Title:	MCC HVAC System Updates			
Number:	PB_738	Release Date:	02/10/2026	
Revision Number:	Not Applicable	Revision Date:	Not Applicable	
Chassis Type:	Saber FR/Enforcer/Velocity/Impel w/ MCC HVAC Systems			
Component Description:	MCC defrost vents and side recirculatory fans			
Warranty:	See Warranty information listed in each section			
Parts:	See parts tables listed in each section

Pierce has implemented two updates to the MCC HVAC system to improve cab air flow and defrost functionality:

Vents:

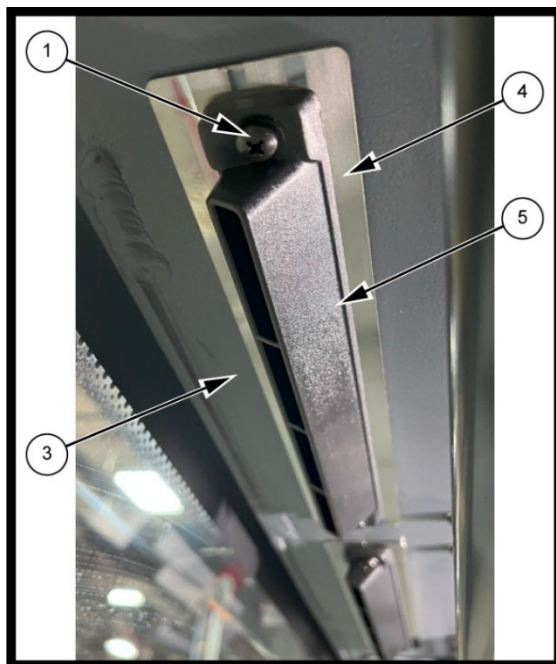
1. Remove two screws (1) and vent (2) from cab (3). Retain screws for installation of new vent.

2. Install adapter plate (4) (PN 4679417) and vent (5) (PN 4679392) on cab (3) with two screws (1).
3. Repeat steps 1-2 for remaining vents.

HVAC Control Unit:

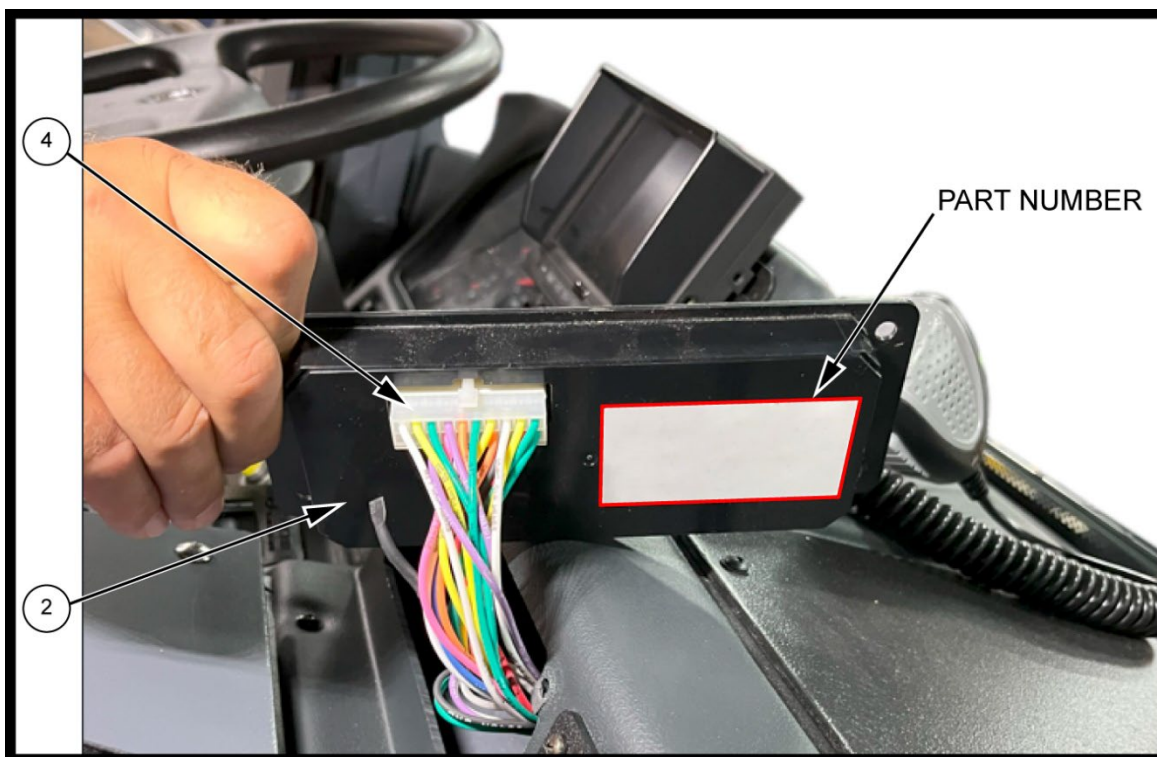
- HVAC control panel Command Zone software must be at least v07.19 to ensure proper HVAC performance and function. Any control panels with previous software versions should be replaced or updated to at least v07.19.
- Replacement HVAC control panel should look the same as existing but contain updated software.

1. Remove four screws (1) and HVAC control panel (2) from dash (3).

2. Check PN on back of HVAC control panel (2) and verify PN is at least 63-4755-0001 (New)/ 4437530 (Refurbished). If your HVAC control panel is older than this, it will need to be replaced.
3. Disconnect connector (4) from HVAC control panel (2).
4. Connect connector (4) to new HVAC control panel (2).
5. Install new HVAC control panel (2) on dash (3) with four screws (1).

Velocity/Impel Installation:

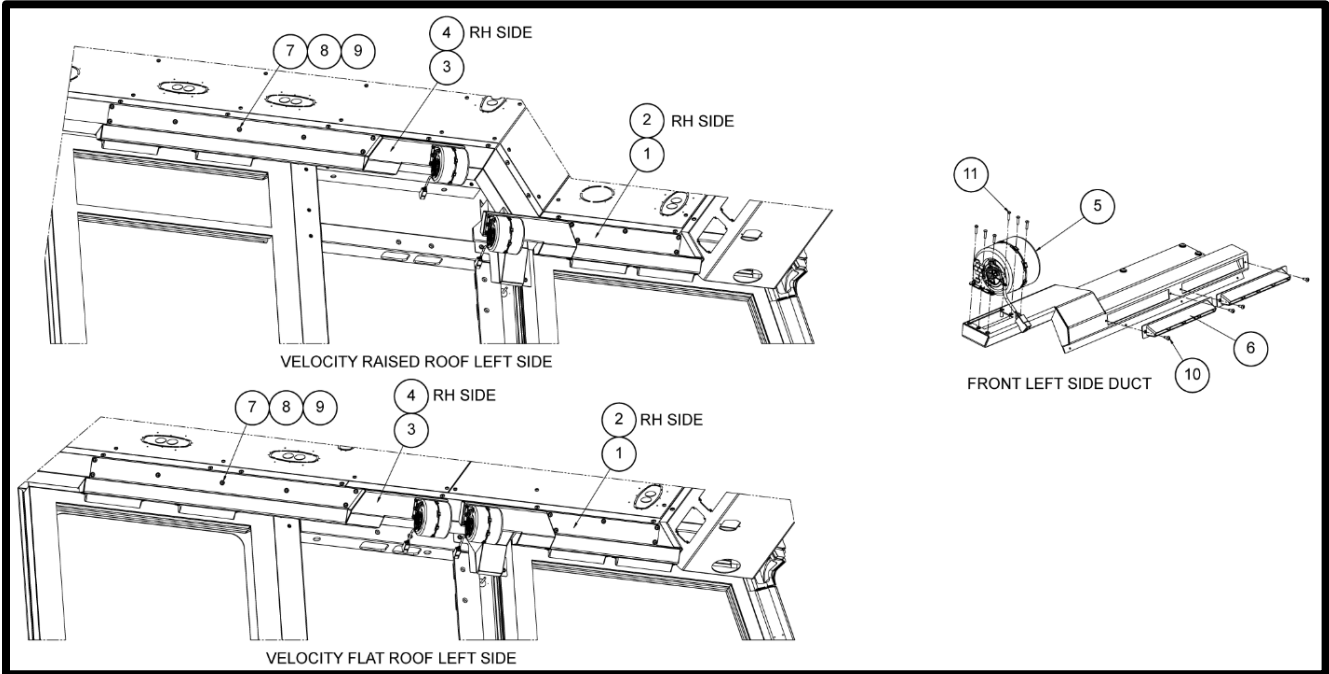
Crew cab vents will need to be centered over the crew cab door, then the panel should be marked for drilling. Front assemblies will have lower mounting holes to be drilled into wire cover and upper holes that share the panel mounting.

Saber FR/Enforcer Installation:

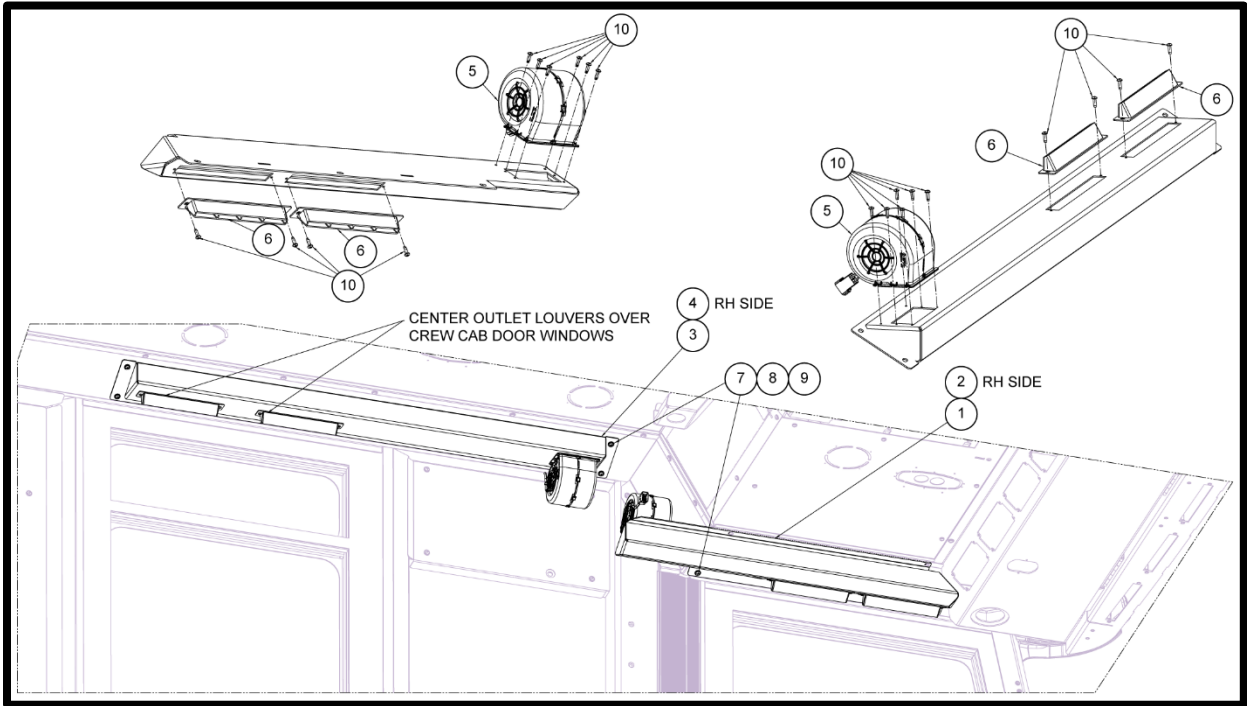
Crew cab vents will need to be centered over the crew cab door, then the panel should be marked for drilling. Front assemblies will have lower mounting holes to be drilled into wire cover and upper holes that share the panel mounting.

Diagram 60-1420-269A

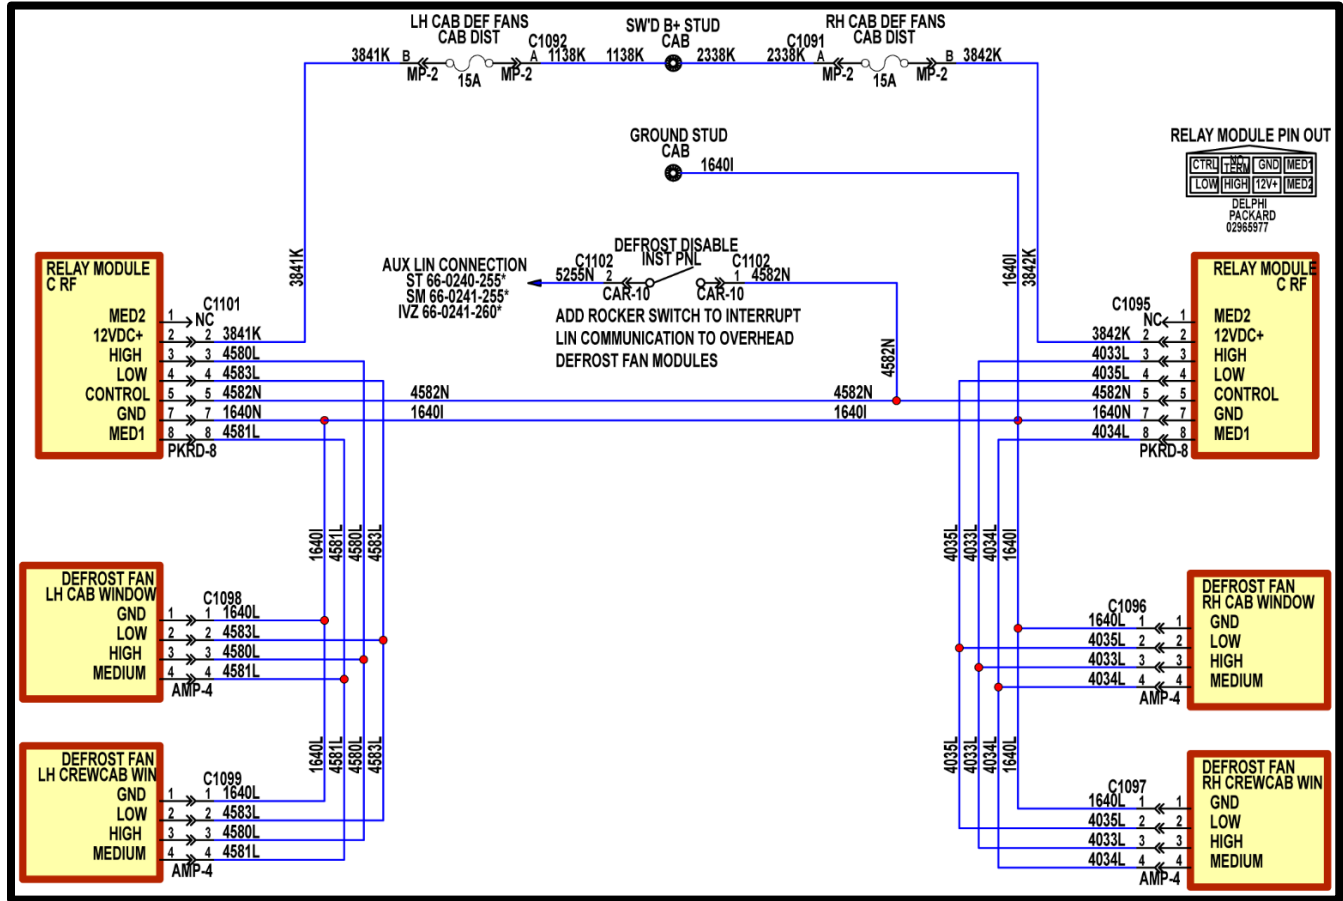
- The kill switch location will need to be determined by the Dealer and have a label ordered with verbiage stating that it shuts off the recirculatory fans (Ex: Aux Fan Disable).
 - Circuit for lin wire #5255 located behind the HVAC control, mounted to the dashboard.
- The ends of the wiring harness will come un-pinned in order to allow for the wire to pass through the hole that is drilled in order to connect to the fans. Pin connector according to print shown above.
